**Schedule of variations from drawings ref: W120/5 (dated Oct. 1998) and W120/11 (dated May 1999), approved 28 Jan 2000, Ref. 3990447P.**

**Barnsteads Barn**  
Waddington Road, West Bradford

Existing Elevations to Barn

Drwg. No.: 2329.E.02 Rev.: A

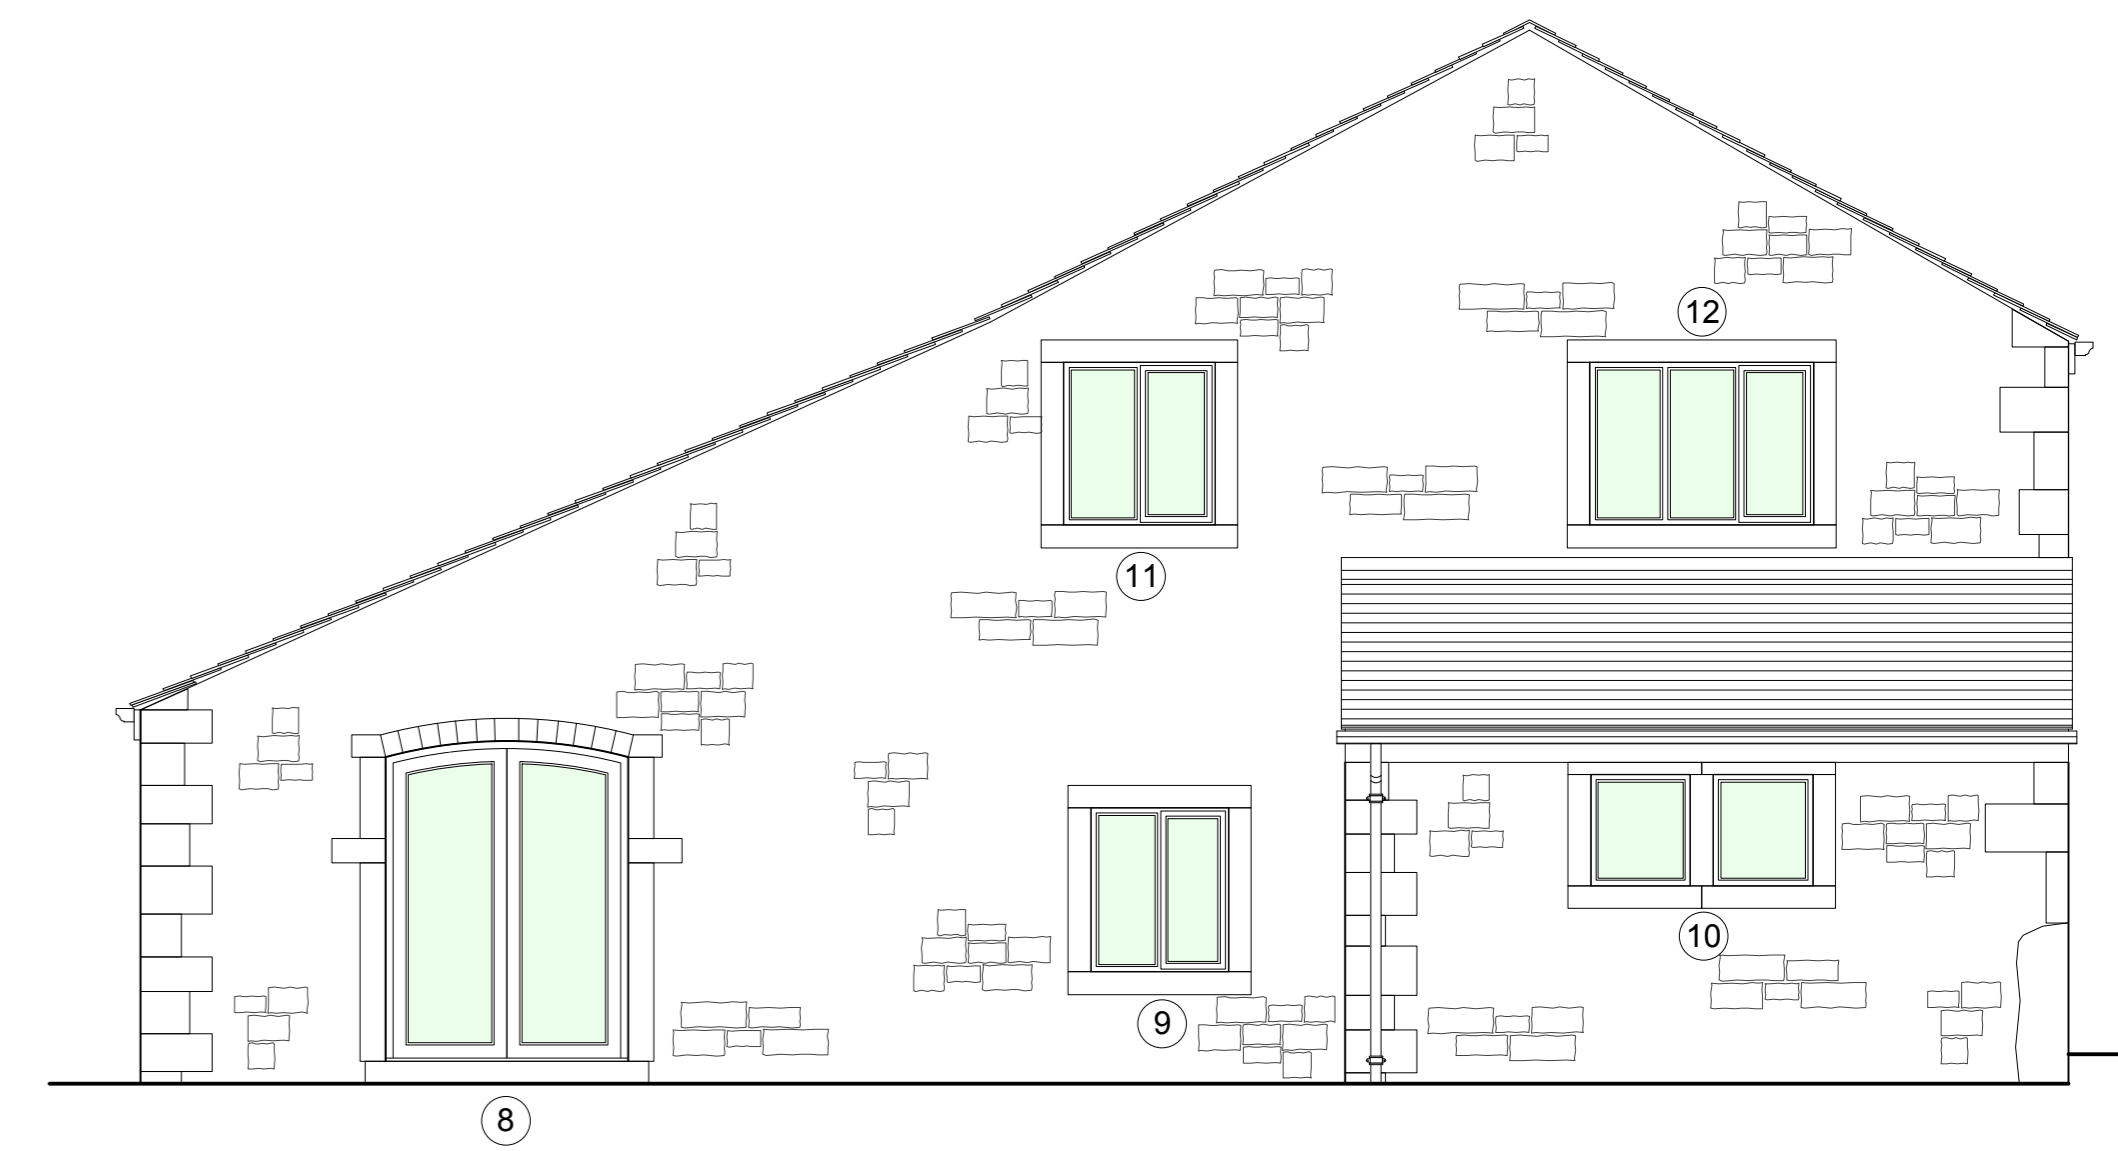
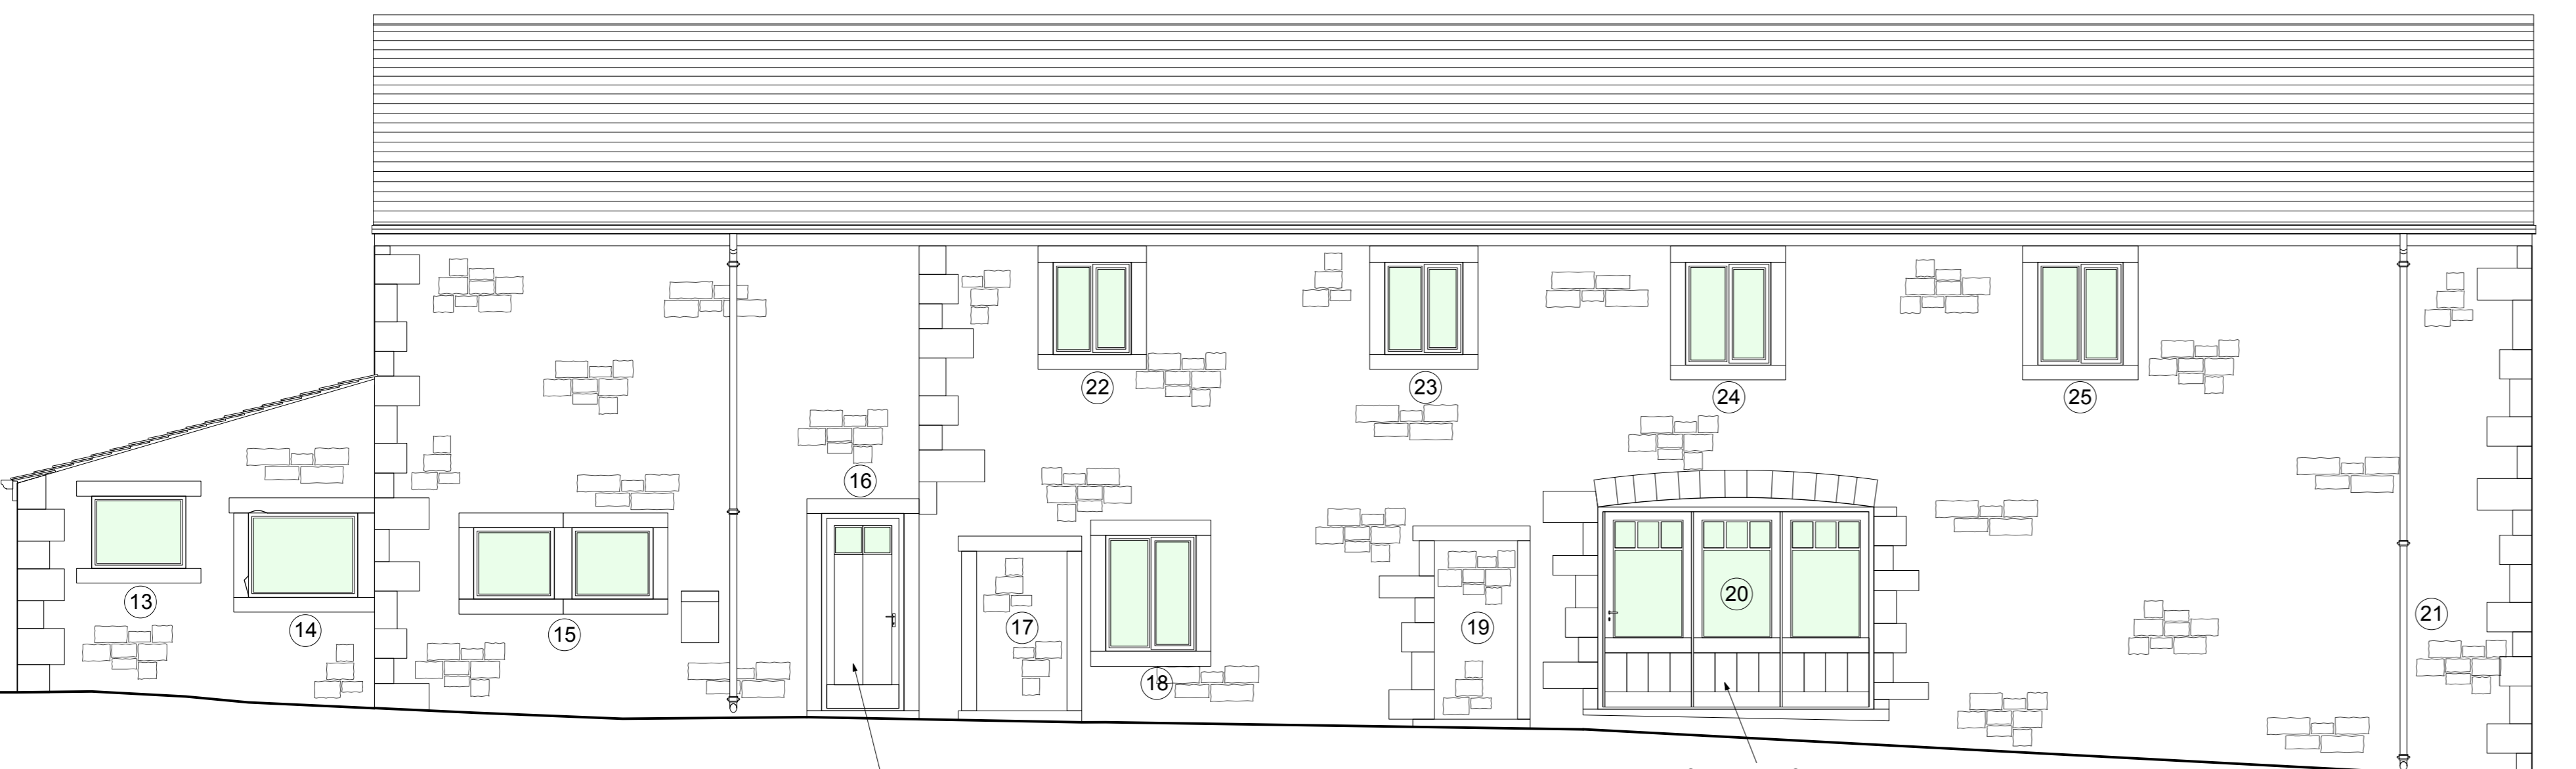
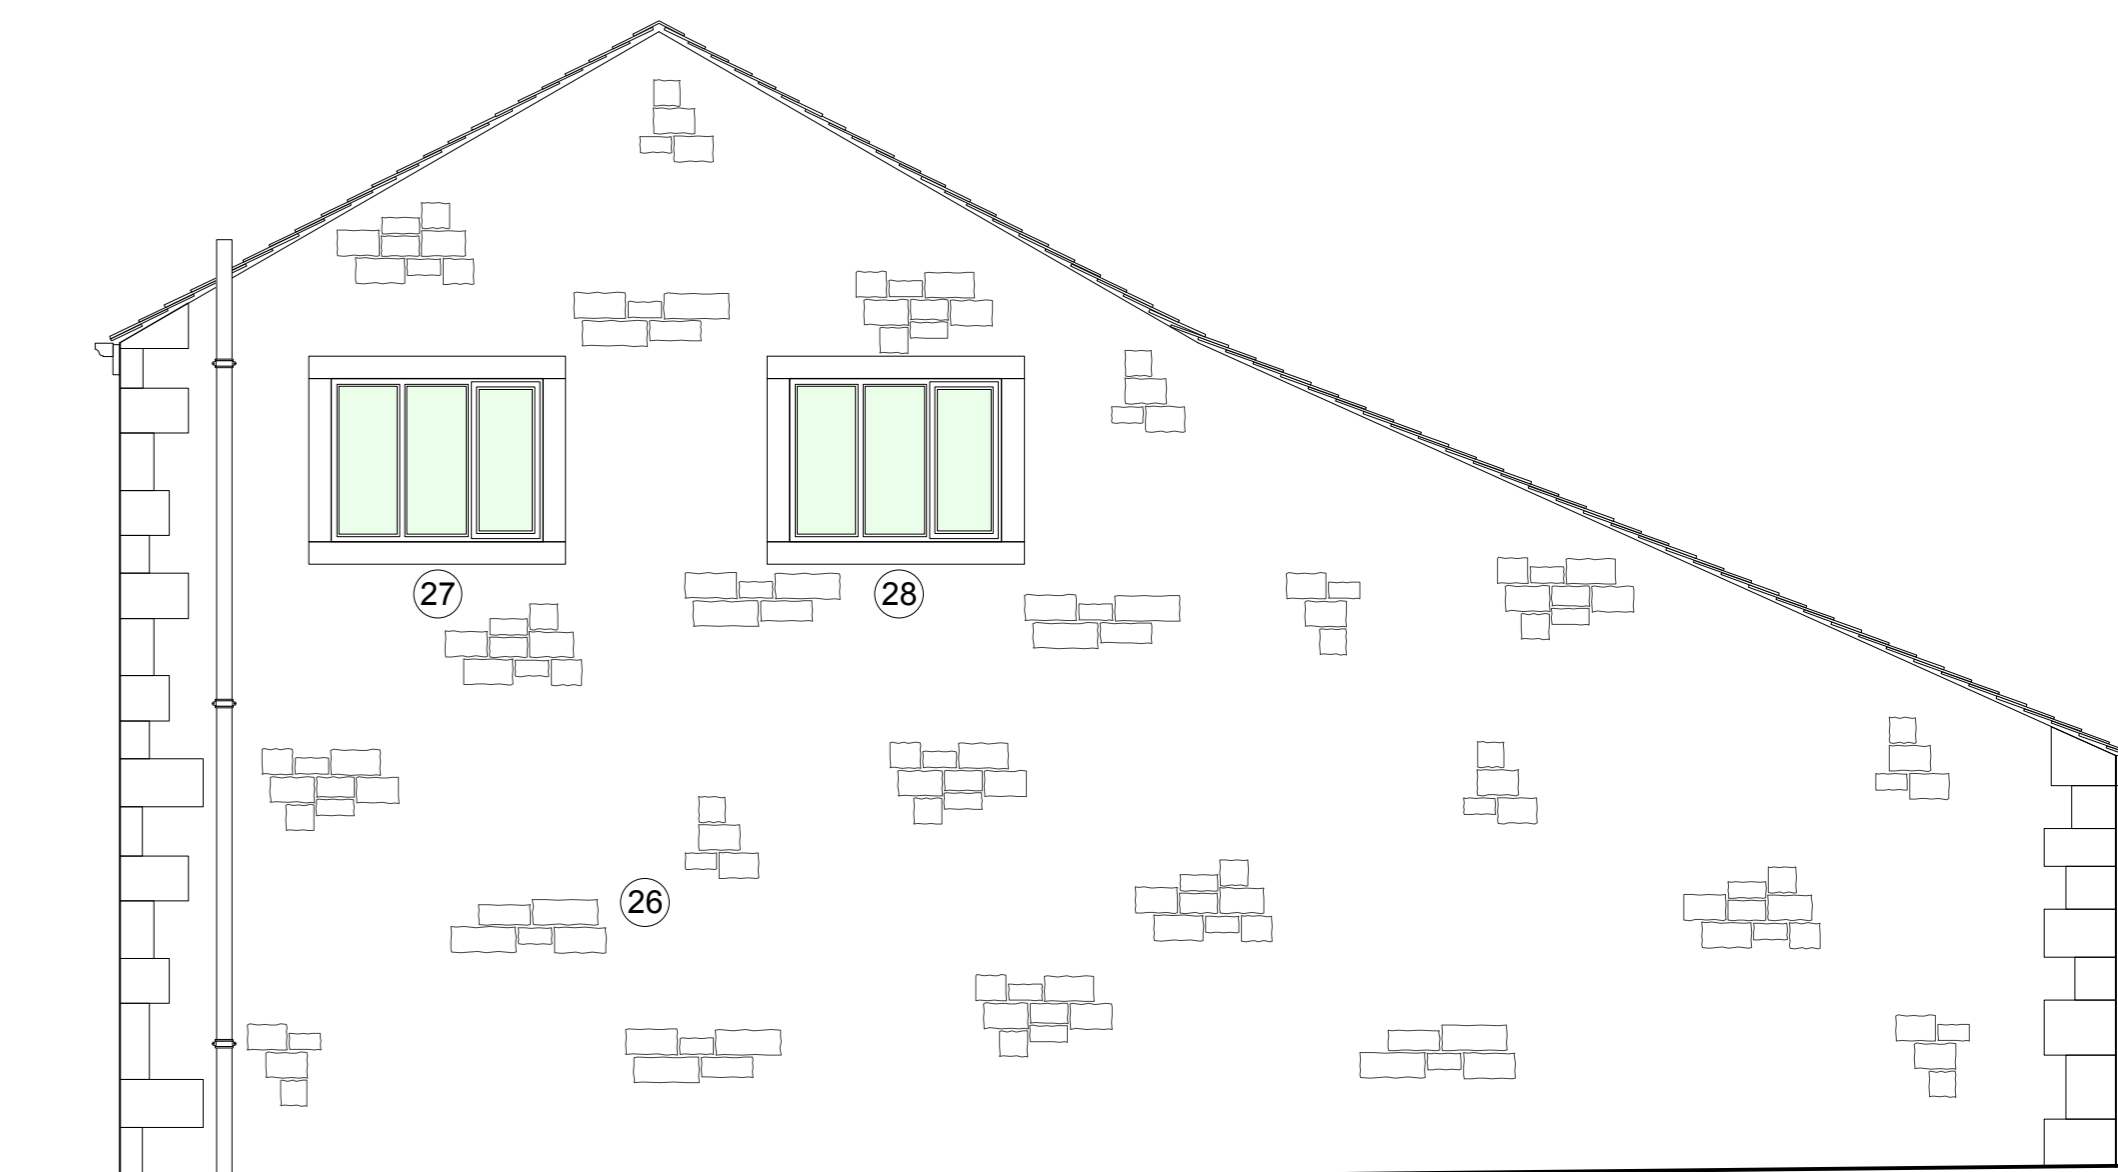
1. Reduced number of roof windows and positions amended.
2. Window pattern amended and material changed from timber to aluminium frames.
3. Ditto.
4. Style changed from half-glazed double doors, to single solid door, with a glazed panel to either side.
5. Window pattern amended and material changed from timber to aluminium frames.
6. Ditto.
7. Window omitted.
8. Style changed from half-glazed double doors with a level head, to full-height glazed double doors in an arched opening.
9. Window pattern amended and material changed from timber to aluminium frames.
10. Window pattern amended, with central stone mullion added and material changed from timber to aluminium frames.
11. Window pattern amended and material changed from timber to aluminium frames.
12. Window pattern amended, with central stone mullion added and material changed from timber to aluminium frames.

13. Window pattern amended and material changed from timber to aluminium frames.
14. Window installed in place of door, with lower half of opening infilled in stonework.

15. Window pattern amended, with central stone mullion added and material changed from timber to aluminium frames.
16. Door installed in place of window, in existing opening.

17. Door omitted and opening infilled.
18. Window installed in adapted original opening.
19. Window omitted and door opening infilled.
20. Folding doors installed with arched head instead of flat.

21. Window omitted and door opening infilled.
22. Window pattern amended and material changed from timber to aluminium frames.
23. Ditto.
24. Ditto.
25. Ditto.

26. Window omitted.
27. Window pattern amended and material changed from timber to aluminium frames. Opening size increased.
28. Window pattern amended and material changed from timber to aluminium frames.

Existing windows, were installed circa 2000, as double-glazed units in aluminium frames. Existing doors were installed as vertical timber boarded, solid doors in timber frames, with glazed panels as shown.
